May 10, 2017

Regarding: Stakeholder Comments on ENERGY STAR® for UPS Draft 1 Version 2.0 Eligibility Criteria

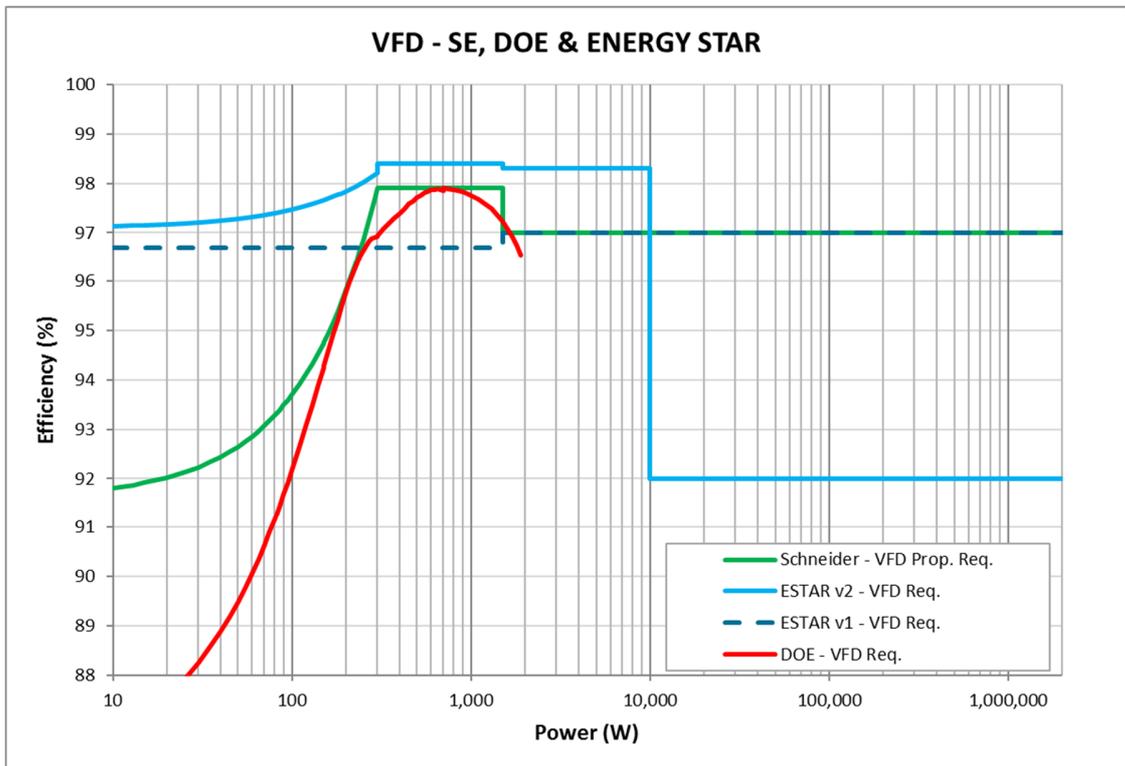
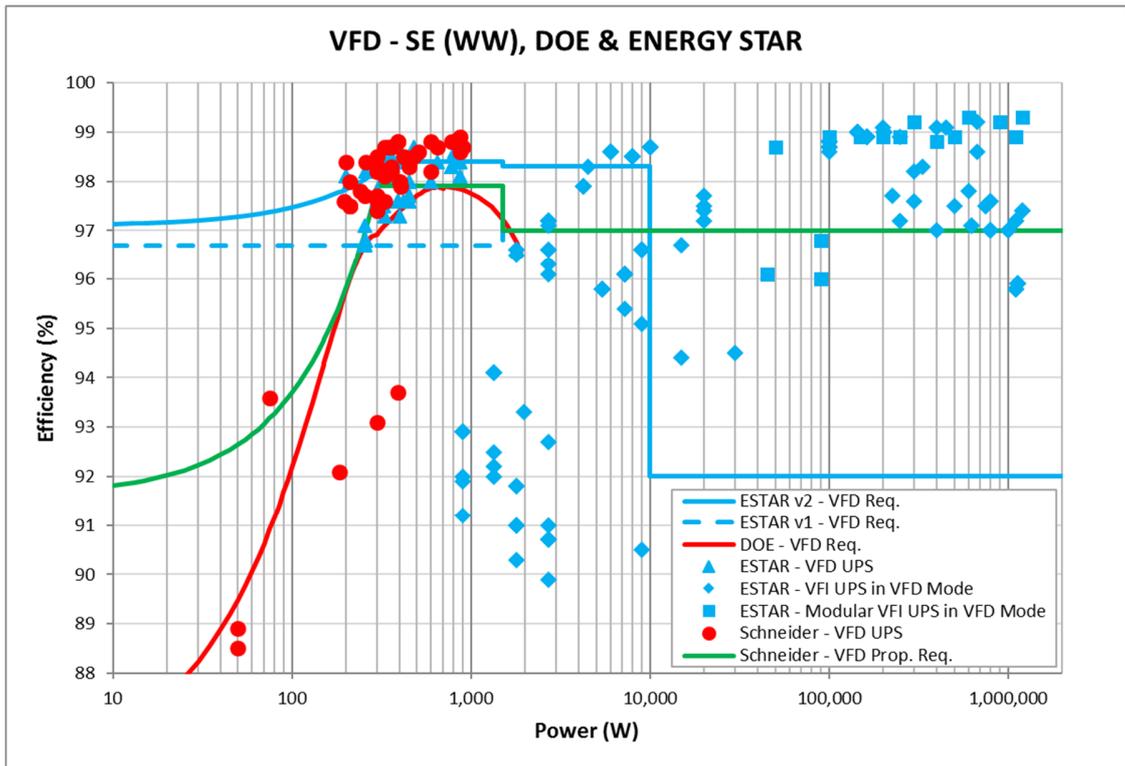
The following charts illustrate our proposed VFD requirements in the context of the Draft 1 Version 2.0 requirements, the Version 1.0 requirements, DOE requirements, ENERGY STAR QPL performance data and Schneider Electric (SE) USA and Worldwide (WW) UPS performance data. Given that there are no identified VFD UPSs on the market rated at greater than 1kW, we used ENERGY STAR QPL data from multimode UPSs as a proxy of what could be achieved by a large dedicated VFD UPS.

Table 1: Ac-output UPS Minimum Average Efficiency Requirement

Rated Output Power	Input Dependency Characteristic		
	VFD	VI	VFI
$P \leq 300 \text{ W}$	$0.00021 \times P + 0.916$	$0.00021 \times P + 0.913$	$0.011 \times \ln(P) + 0.822$
$300 \text{ W} < P \leq 1500 \text{ W}$	0.979	0.976	
$1500 \text{ W} < P \leq 10,000 \text{ W}$	0.970	0.970	$0.011 \times \ln(P) + 0.822 - E_{MOD}$
$P > 10,000 \text{ W}$		0.950	$0.006 \times \ln(P) + 0.868$

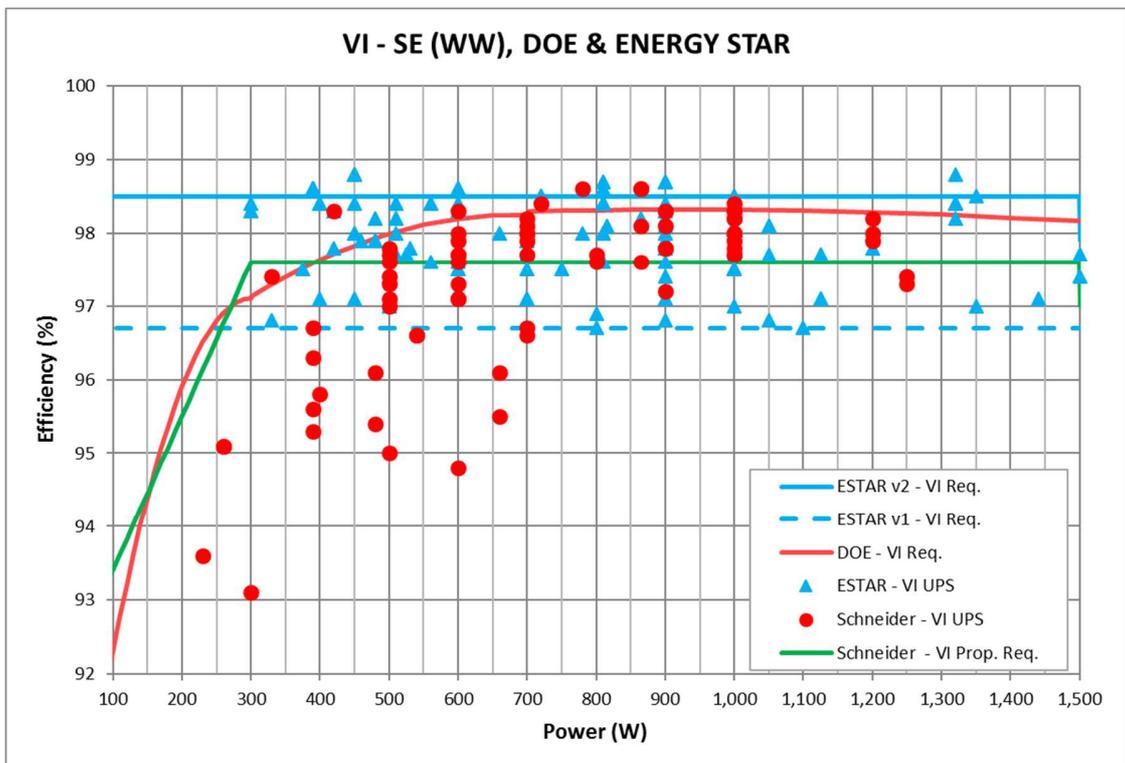
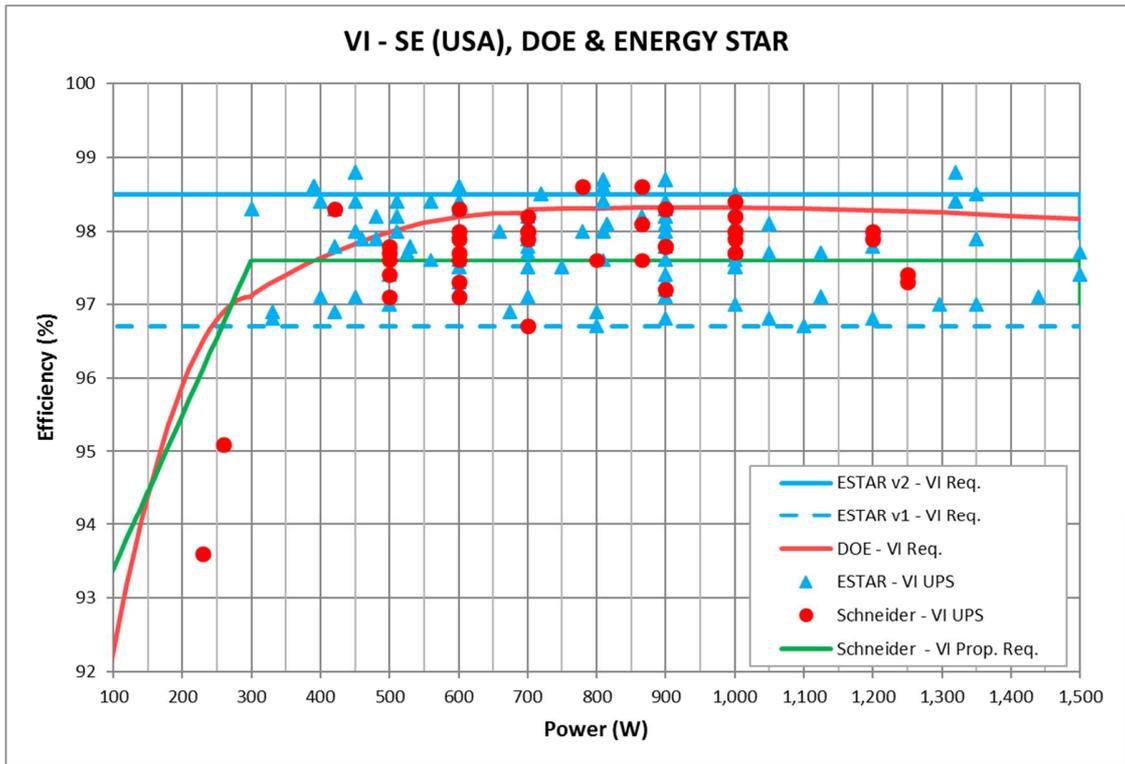
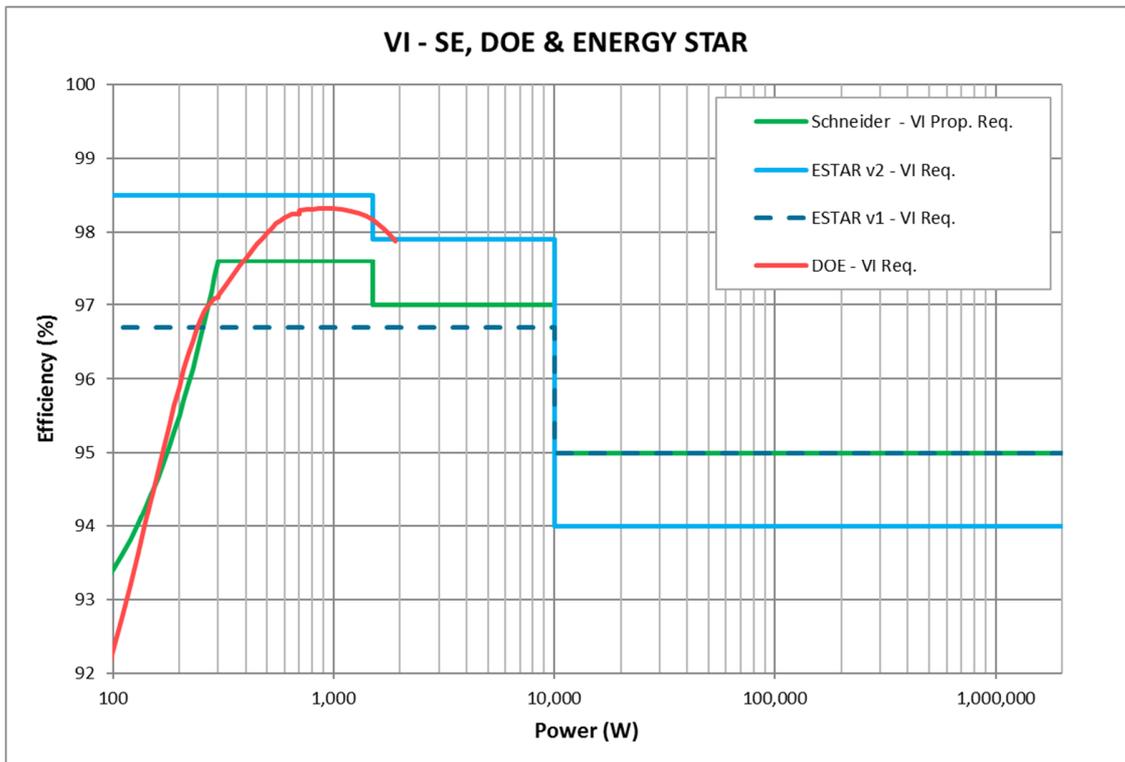
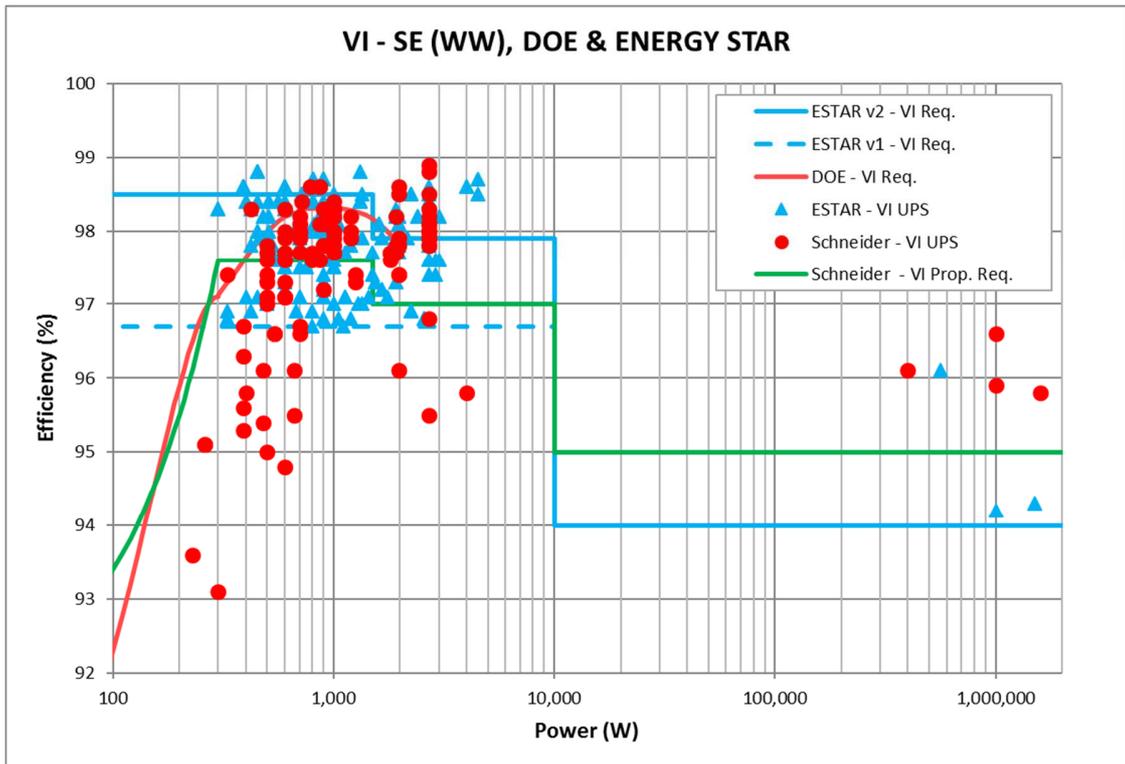
The following charts illustrate our proposed VI requirements in the context of the Draft 1 Version 2.0 requirements, the Version 1.0 requirements, DOE requirements, ENERGY STAR QPL performance data and Schneider Electric (SE) USA and Worldwide (WW) UPS performance data.

Because both Rotary and solid-state UPS systems can deliver VI performance, lowering the requirement for VI > 10kW just to ensure Rotary models can qualify is inconsistent with the goals of the ENERGY STAR program. We therefore request that the Version 1.0 requirement be maintained for this category.

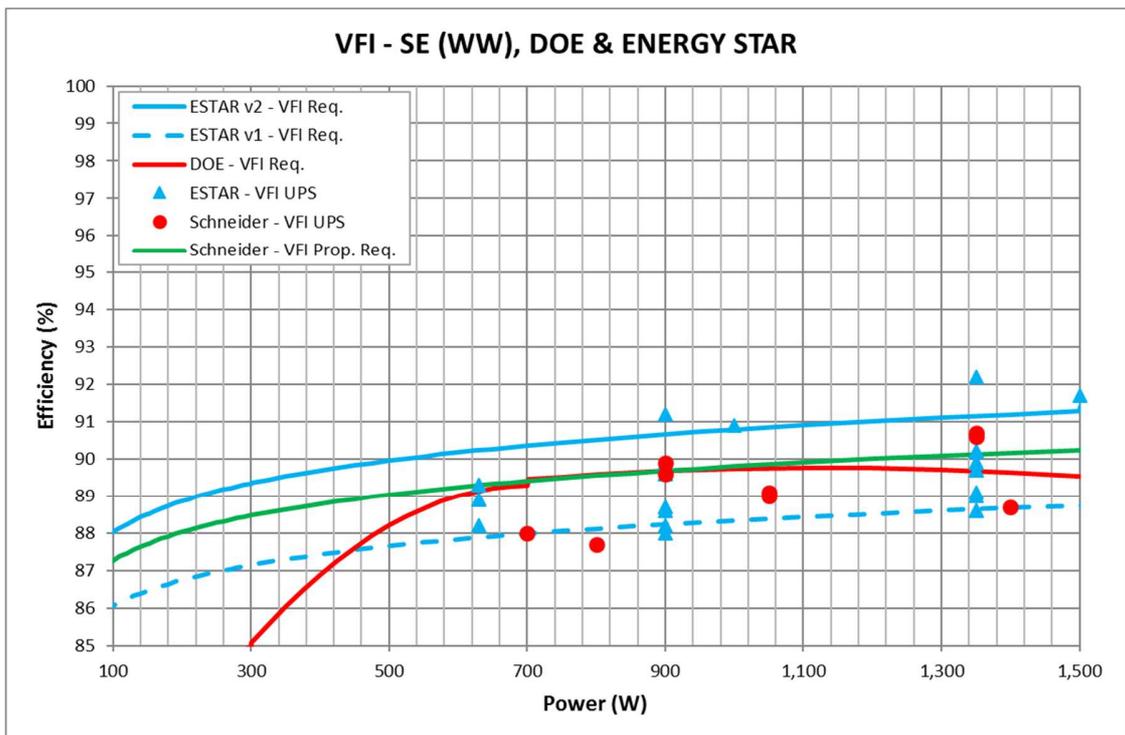
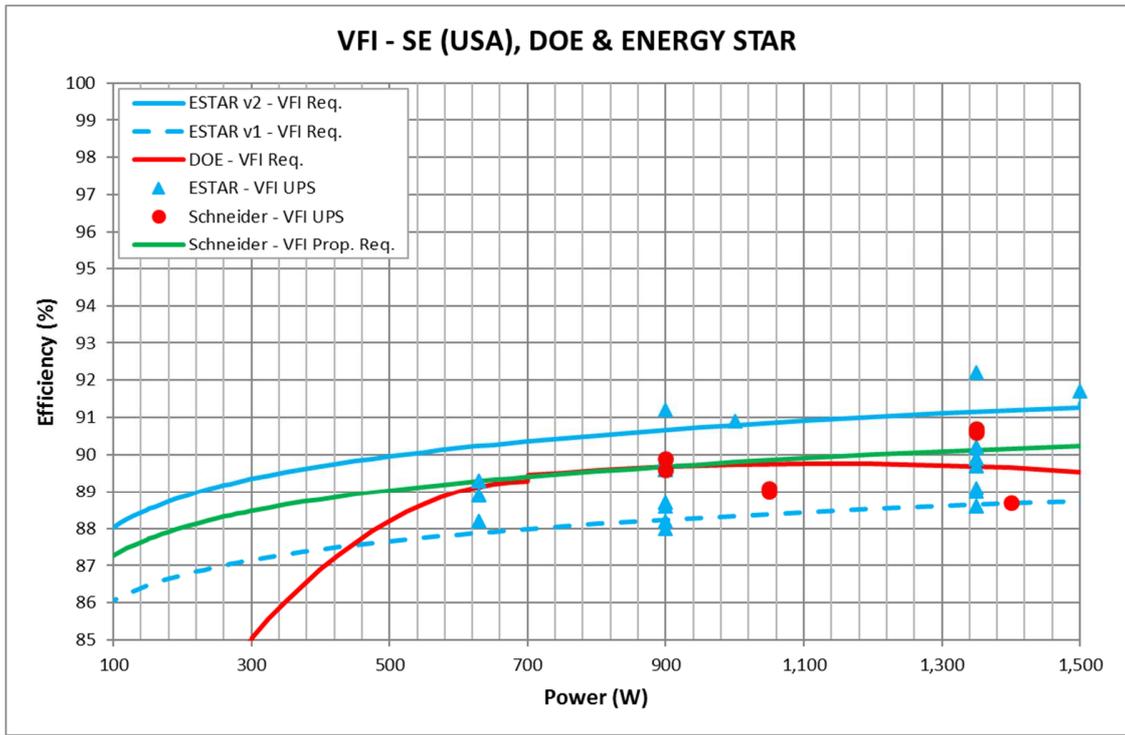
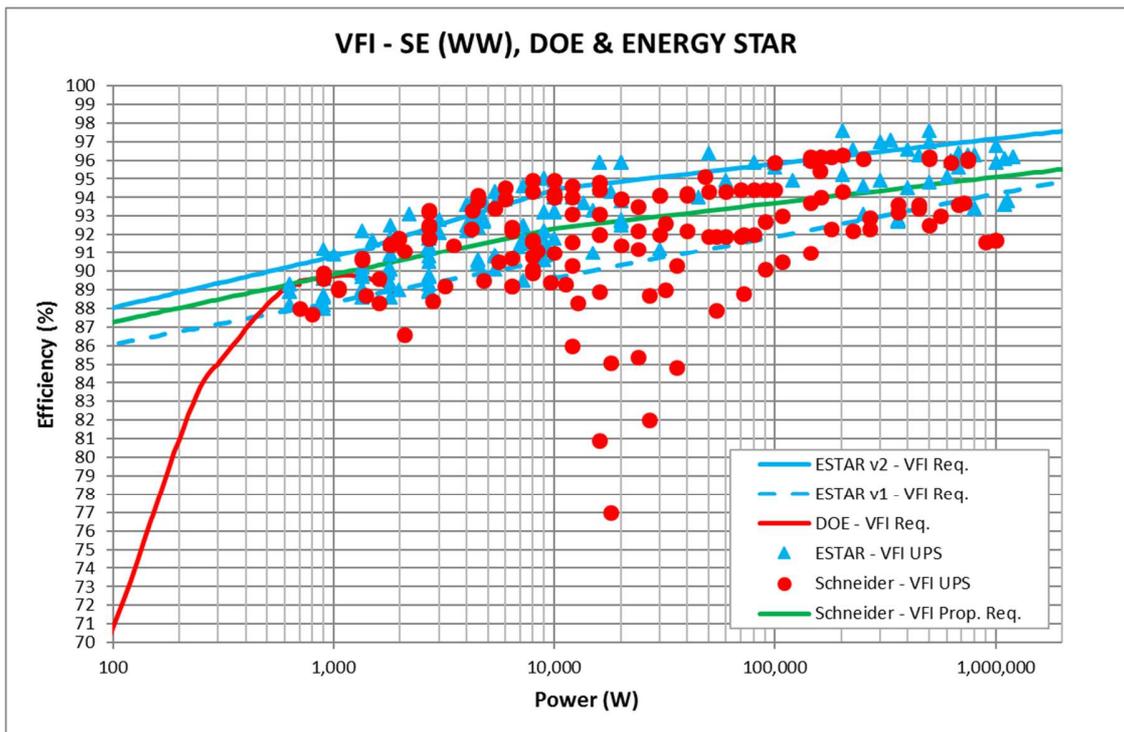
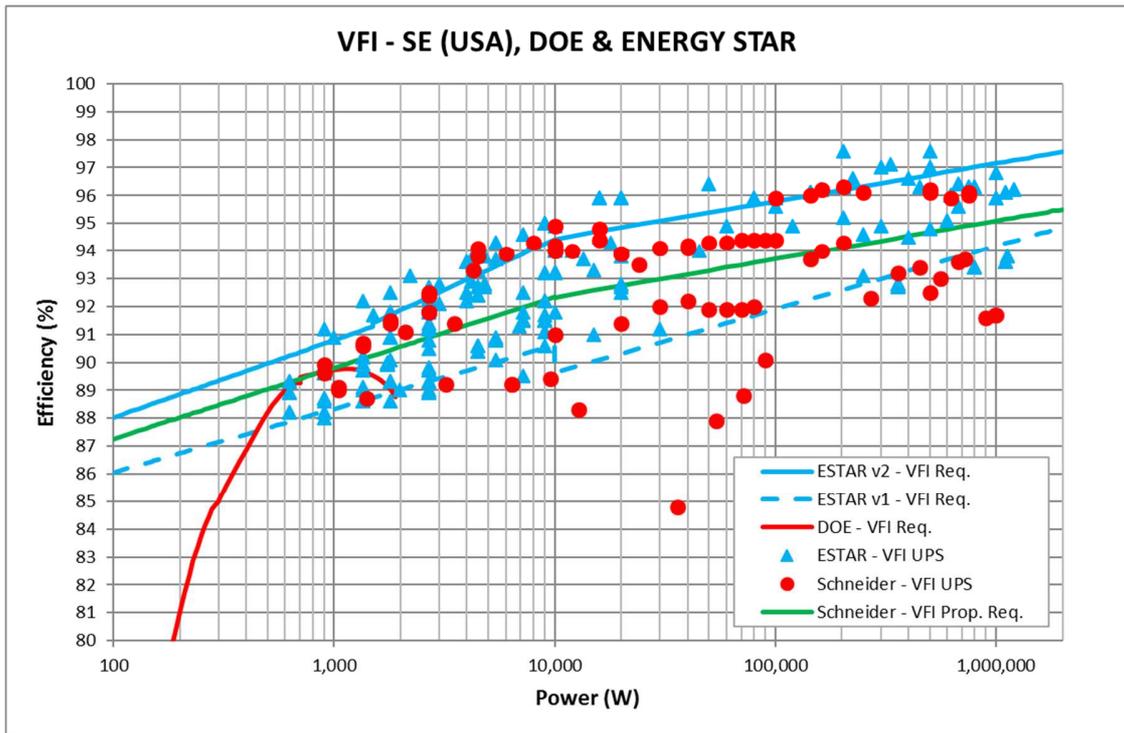
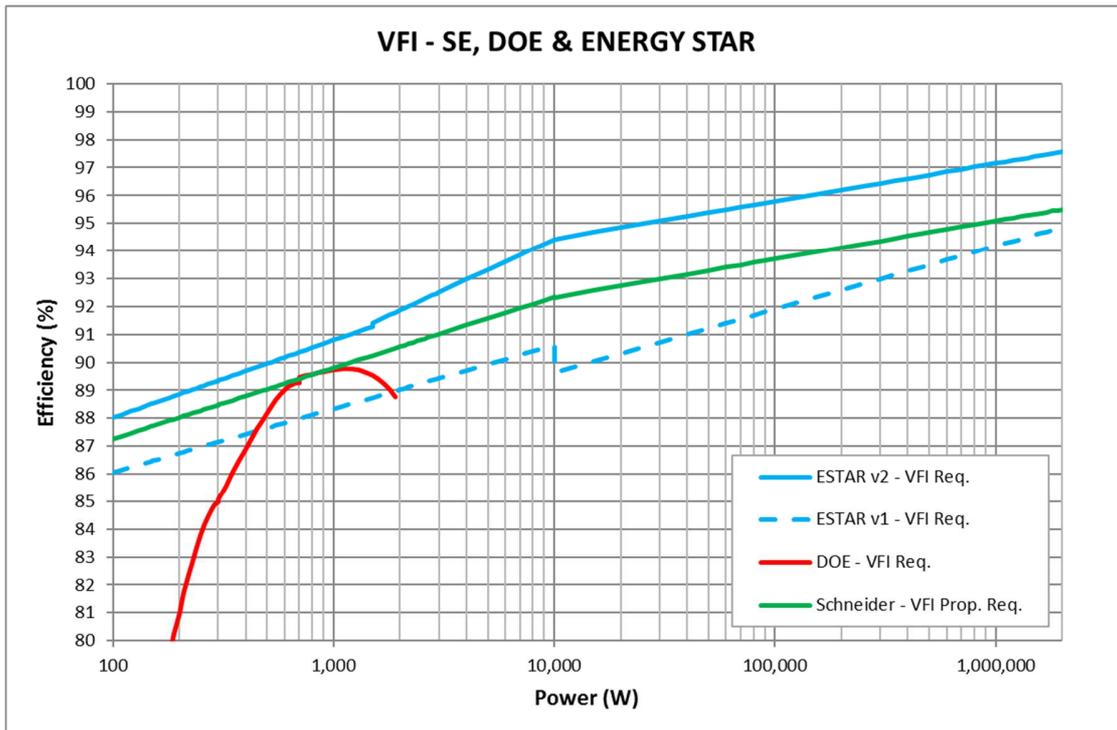
The following charts illustrate our proposed VFI requirements in the context of the Draft 1 Version 2.0 requirements, the Version 1.0 requirements, DOE requirements, ENERGY STAR QPL performance data and Schneider Electric (SE) USA and Worldwide (WW) UPS performance data.

As the data above illustrates, we currently manufacture and sell UPSs in every category, both in the USA and globally, that do not meet the ENERGY STAR Version 1.0 requirements. This fact is most obvious in the Data Center VFI market above 10kW. Consequently, we know with certainty that broad assertions of market penetration approaching 100% are not accurate.
